**BROWNS FERRY NUCLEAR PLANT (BFN) - UNITS 1, 2, and 3
EMERGENCY PLAN IMPLEMENTING PROCEDURE (EPIP) REVISIONS**

TVA is submitting this notification in accordance with the requirements of 10 CFR Part 50, Appendix E, Section V. Specifically, several EPIPs were revised: (1) EPIP-1, Revision 33; (2) EPIP-2, Revision 23; (3) EPIP-3, Revision 26; (4) EPIP-4, Revision 25; (5) EPIP-5, Revision 30; and (6) EPIP-8, Revision 15. The revisions have an effective date of July 30, 2002.

EMERGENCY PLAN IMPLEMENTING PROCEDURES (EPIP)
EPIP-1, EPIP-2, EPIP-3, EPIP-4, EPIP-5, AND EPIP-8

ATTACHMENT C (Page 1 of 1)
PROTECTIVE ACTION RECOMMENDATIONS

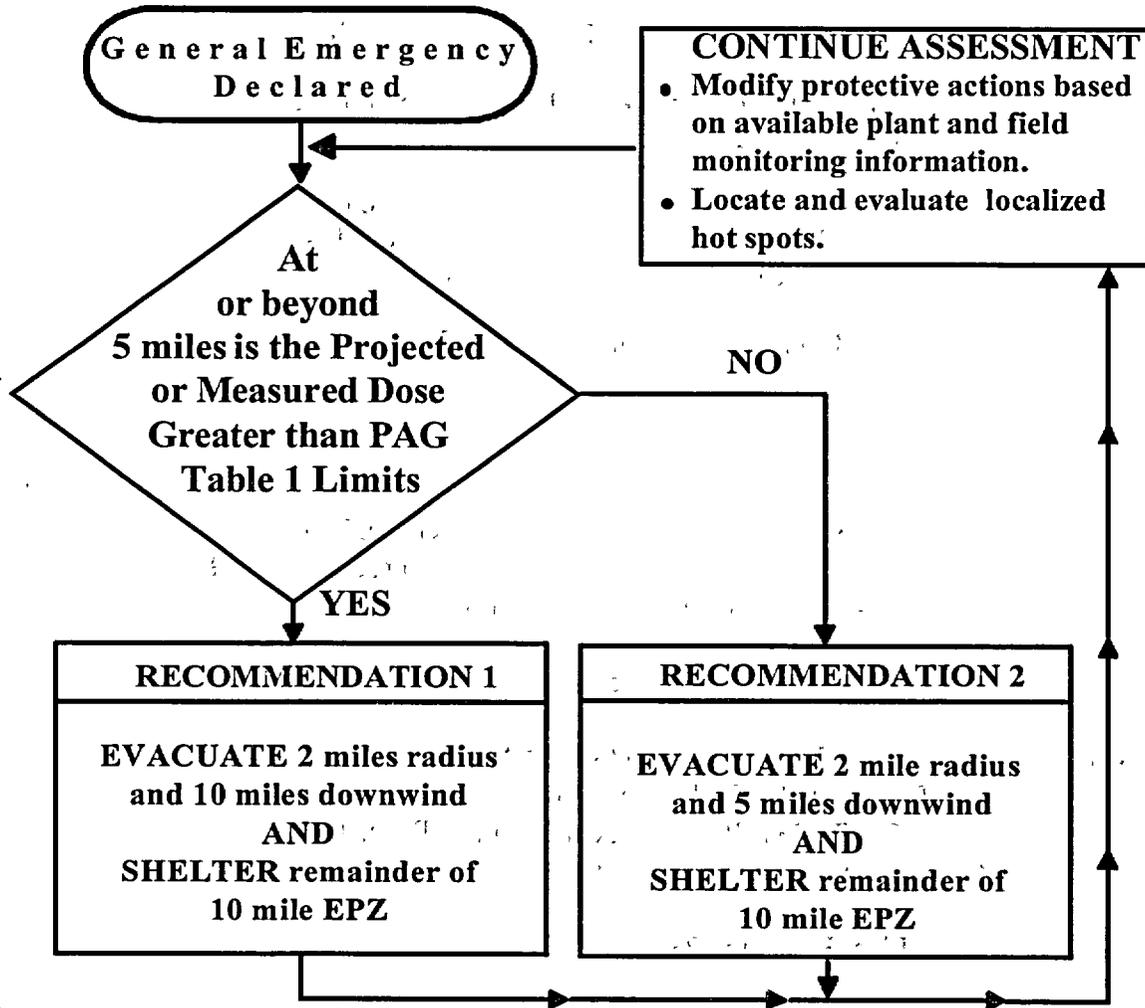
- Page 10 - revised to update information supporting Unit 1 Operator actions regarding ERO staffing support.
 - Page 11 - revised Protective Action Recommendation Flowchart.
